FT5184 Safety Vision Camera system connection issues

Manual section 17

QJ 7621 - 2268

Safety Vision Camera System Issues Solutions for LD82

Problem 3 – Cable Routing & Handling

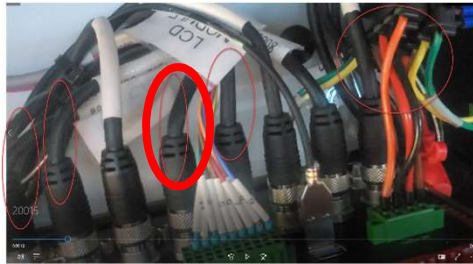
- The POE Cables connected to the NVR were too tight, stressed, and even 90° bending of the cables were observed.
- No agreed installation requirement provided by the vendor.

- 3"- 4" of slack at each end of the cables. (extra length loops vetted by PM Services)
- Avoidance of 90° bending
- Enabled free movements of the cables during Transit (Bad roads at Baltimore)
